AGENDA
BOARD OF PUBLIC WORKS MEETING
Tuesday, April 26, 2022 at 6:00 p.m.
Jackson Municipal Complex
Village Board Room
N168W19851 Main Street
Jackson, WI 53037

PROJECT:
MAPLE FIELDS - PHASE 1
SINGLE FAMILY RESIDENTIAL SUBDIVISION
VILLAGE OF JACKSON, WISCONSIN
BY: NEUMANN DEVELOPMENTS, INC.
N27W24025 PAUL COURT, SUITE 100
PEWAUKEE, WI 53072

C4.3

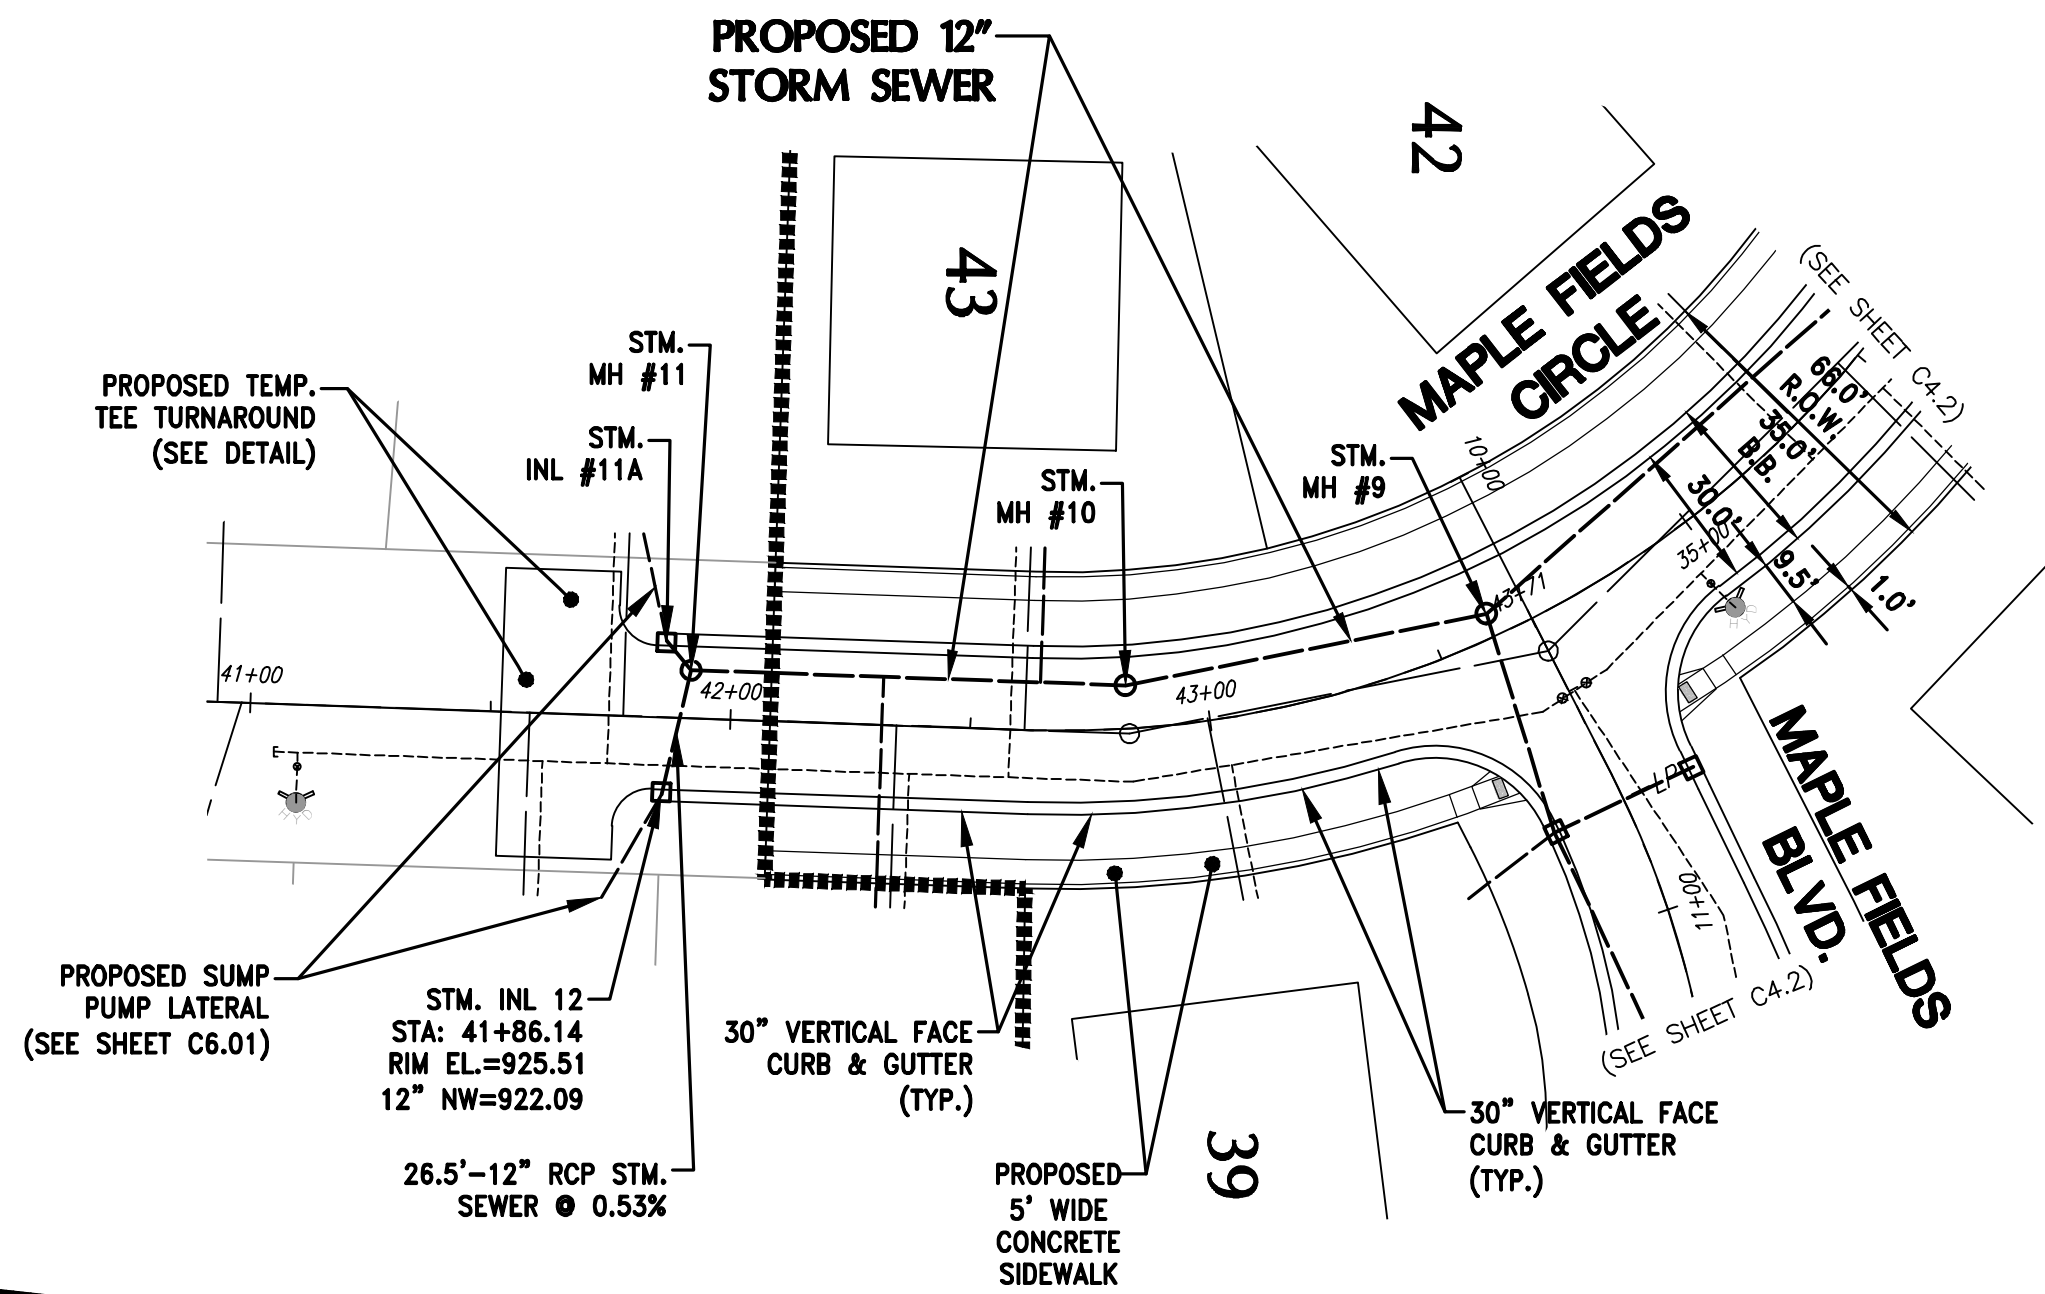
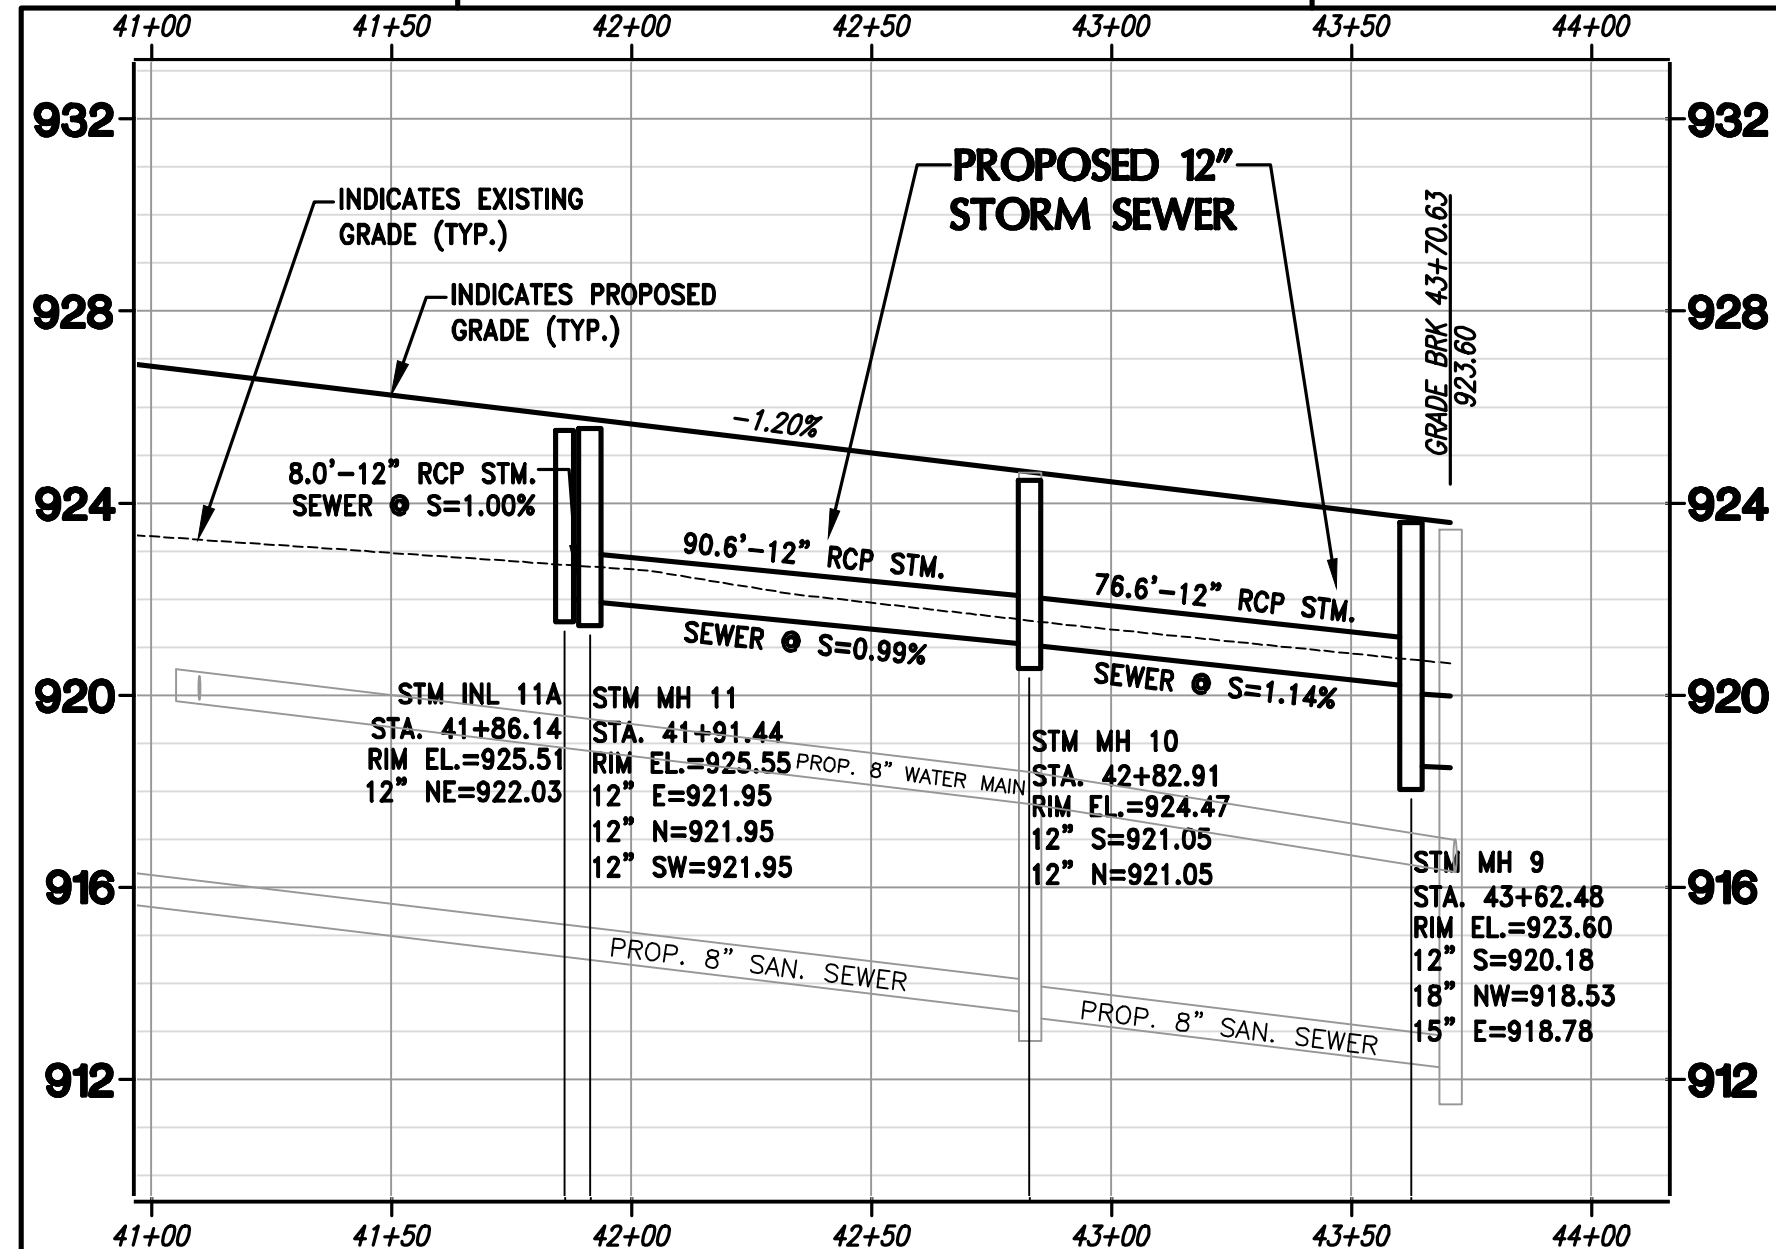
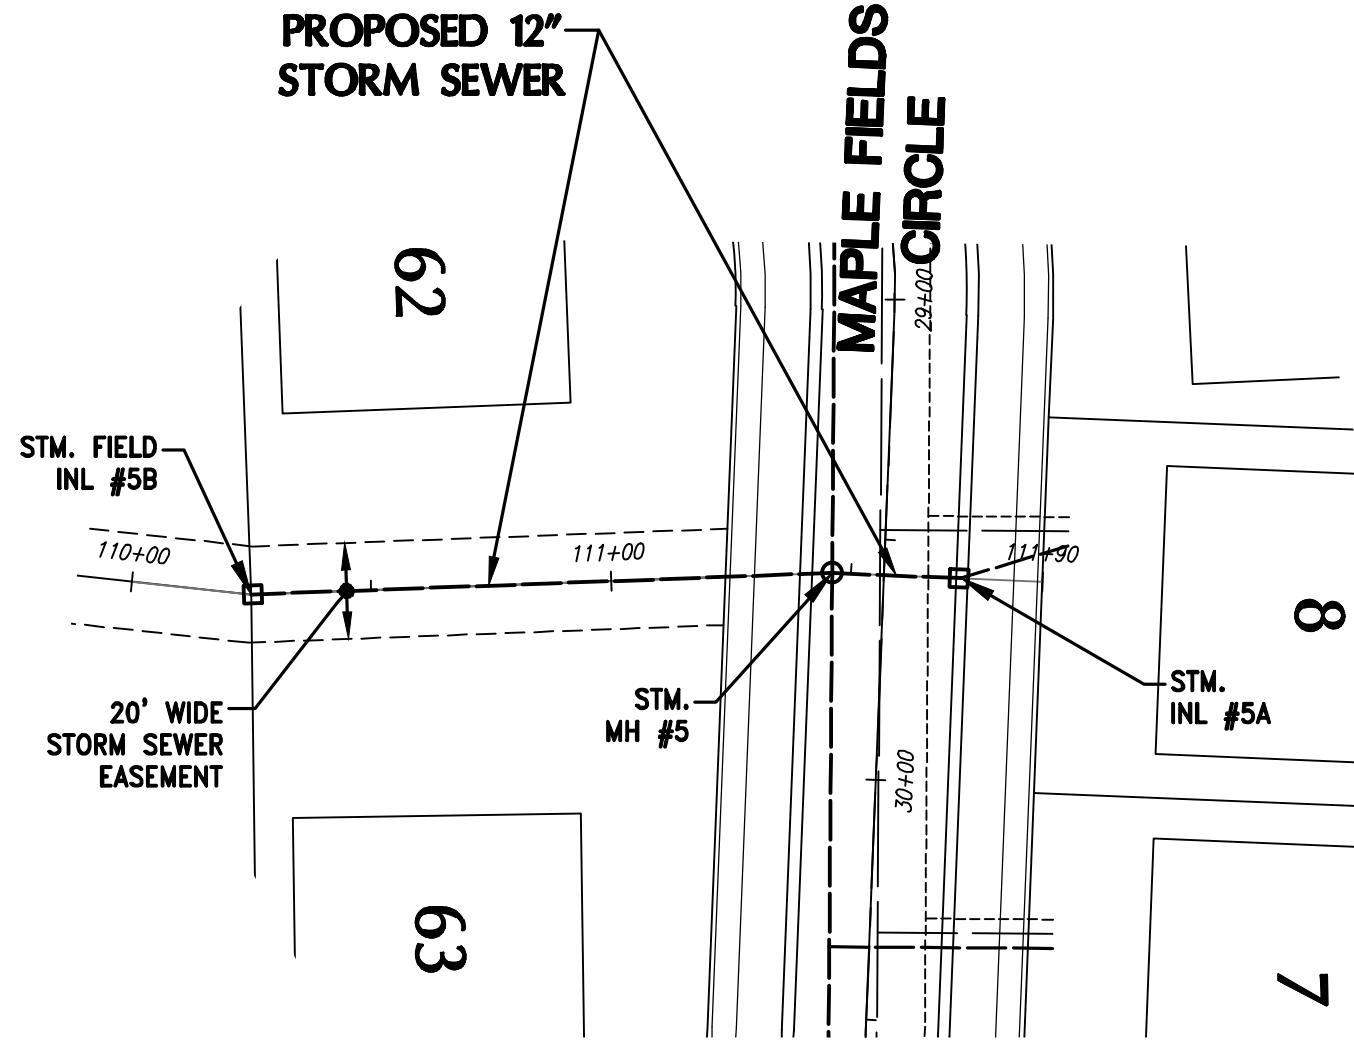
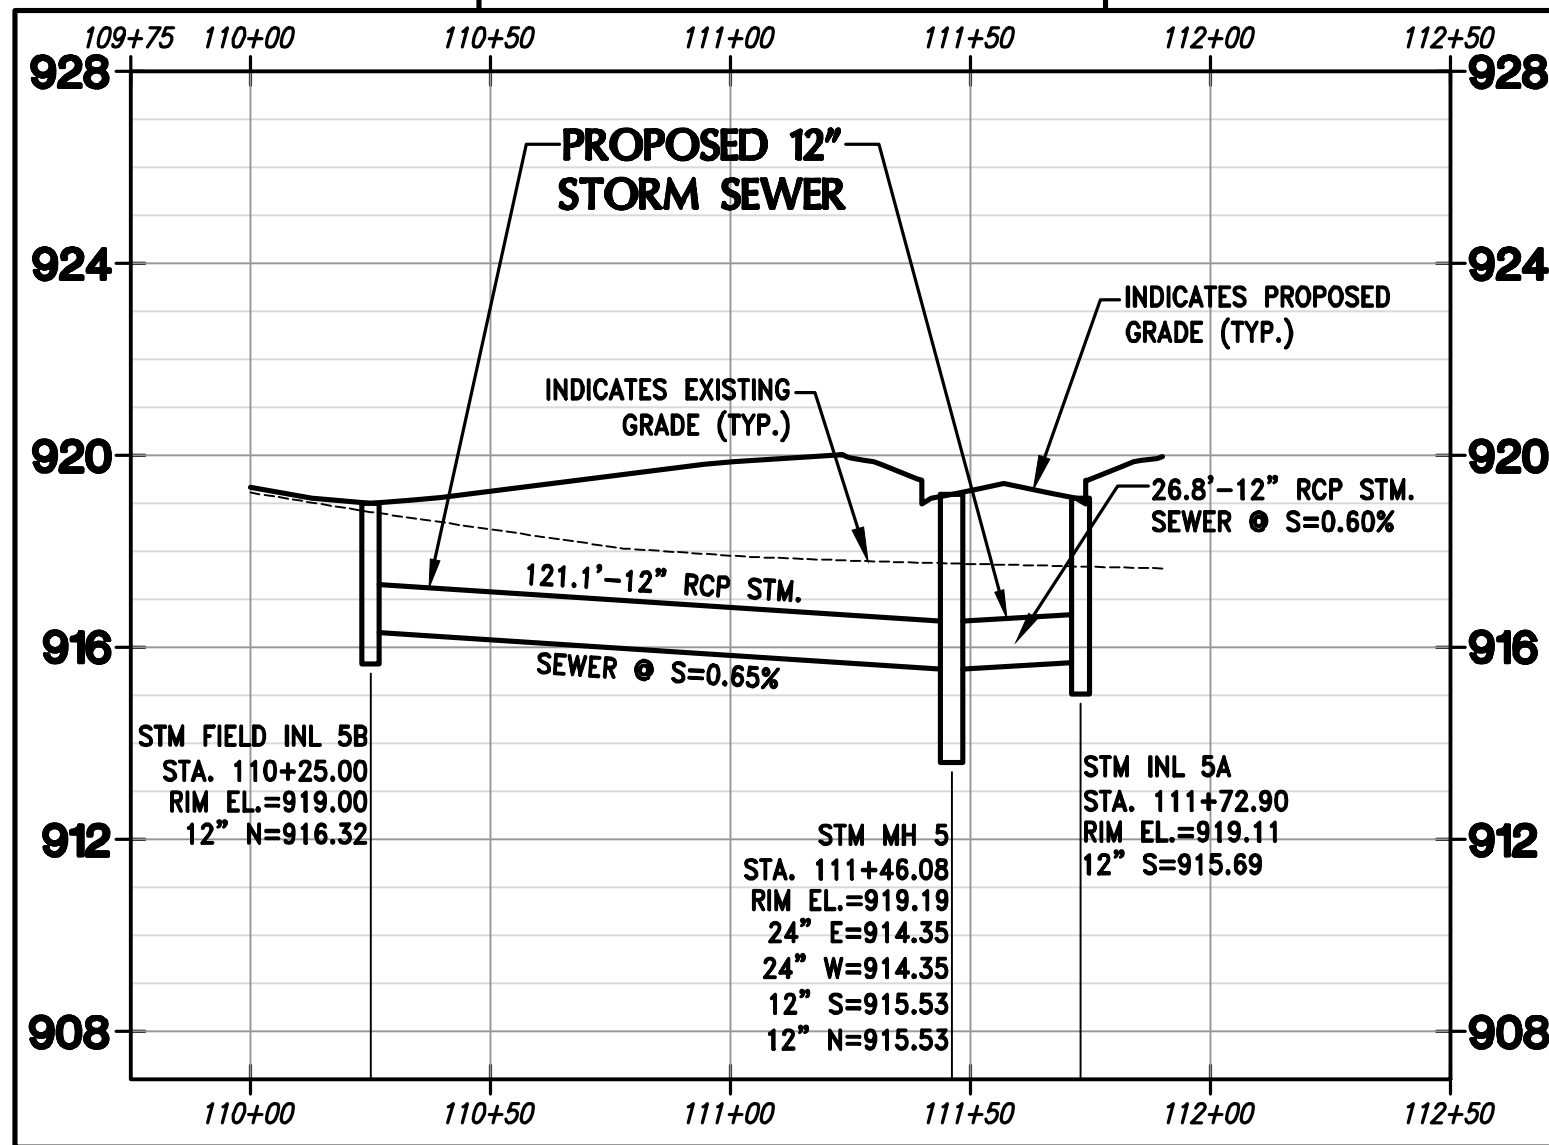
- 19) Sheet Number C4.3 The storm sewer main shall be installed in the Paloroma Court pavement area and not behind the curb.
- 20) Sheet Number C6.0 The Jackson Sewer Utility requires Ladtech rings to be used for adjustment rings. See attached detail. Also, attached is the new hydrant detail.

12" DIA. SUMP PUMP COLLECTOR CLEAN OUT DETAIL

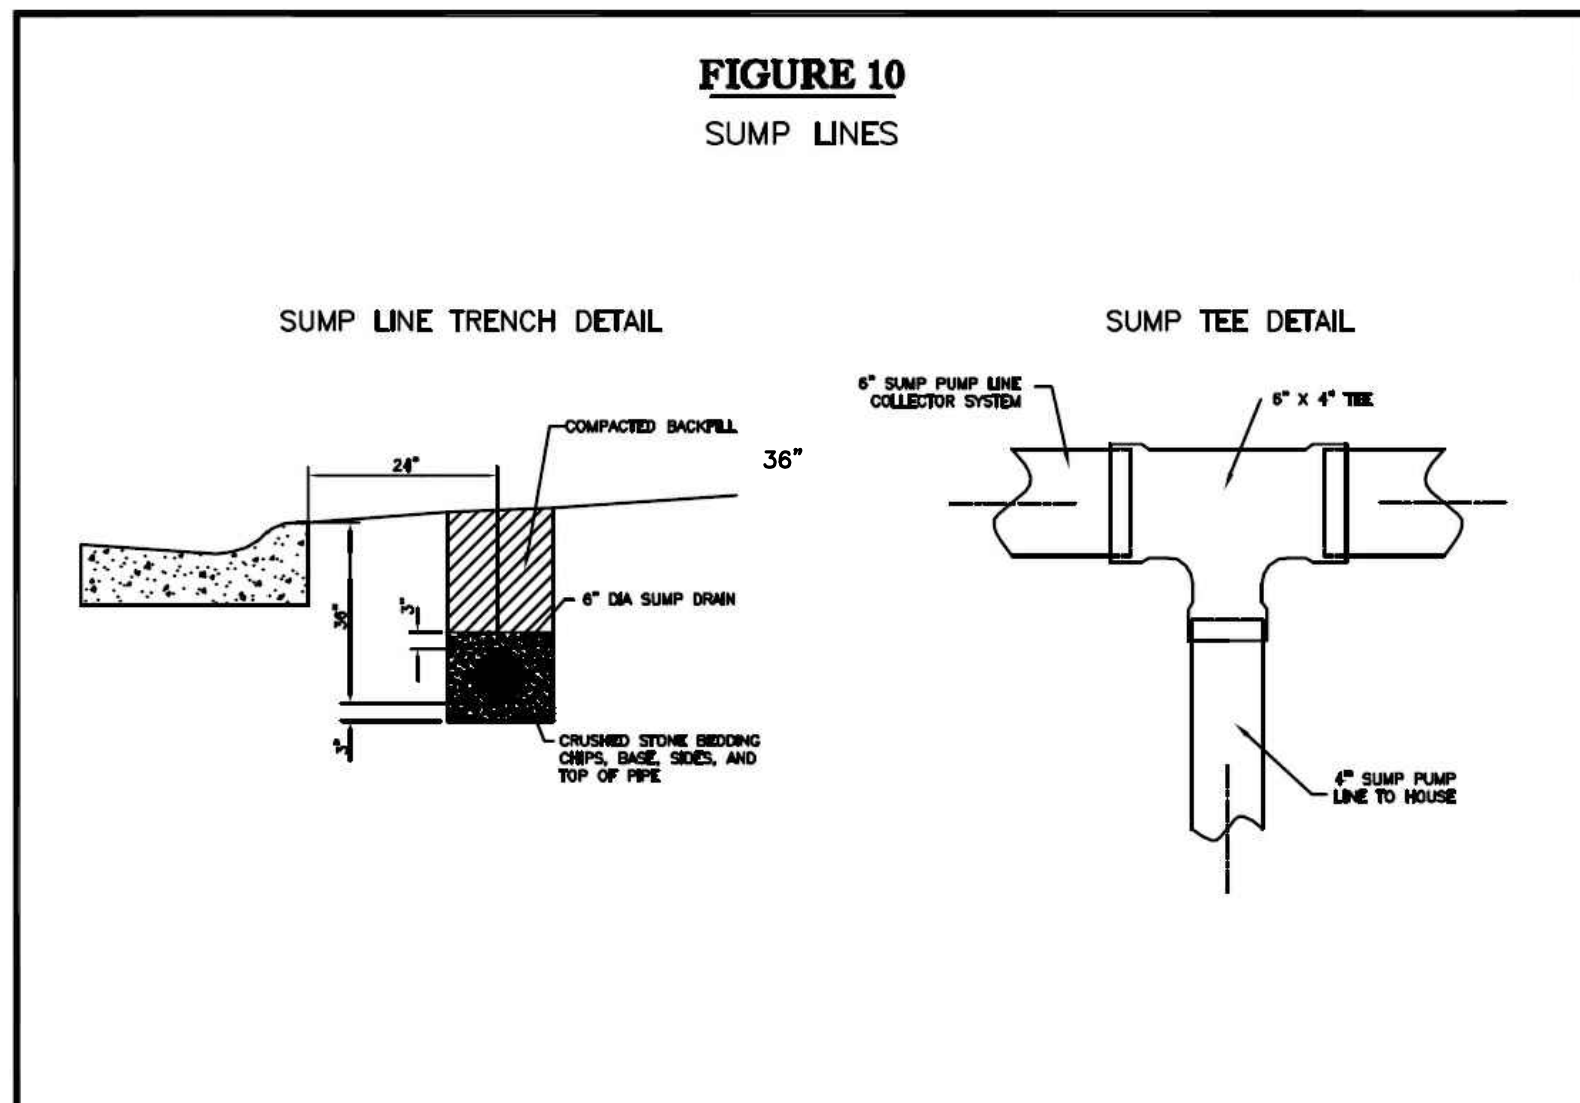
- 21) Sheet Number C6.0 The Village standard for "Road Cross Section" is 5-inches of asphalt and 9-inches of base course. See attached details.
- 22) Sheet Number C6.1 Remove 12-inch Dia Sump Pump Collector Clean Out Detail and Figure 10 since the details are not needed.
